## **DORFOLD / BETLEY / TOLLIT COLOURS:**

### **VICTORIA STREET COLOURS:**

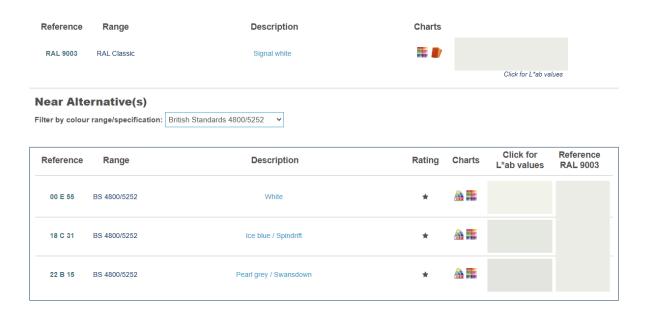
Further to our conversation just now, I will amend the colours so they remain to the BS4800 standard as per the previous guidance except for the Dulux 'county cream' which will be converted to the nearest BS 4800 equivalent. The colours referenced in the documents will be as follows:

- External front doors & external rear timber gates: BS 4800 14 C 39 'Hollybush' ( Unchanged from previous guidance)
- Stone Cills: BS 4800 14 C 39 'Van Dyke' (Unchanged from previous guidance)
- Rainwater goods and metal gates to porches: BS 4800 00 E 53 'Black' (Previous guidance stated rainwater goods to be 'black')
- All Window frames / Rear external doors /eaves & bargeboards etc...: BS 4800 10 C 31 'Ivory / Champagne / Buttermilk' ( Previous guidance stated Dulux ' County Cream' Note, there is no direct BS 4800 match for this and therefore the proposed colours will be 'slightly different'. Please see below )
- Internal Porches: tbc, please advise
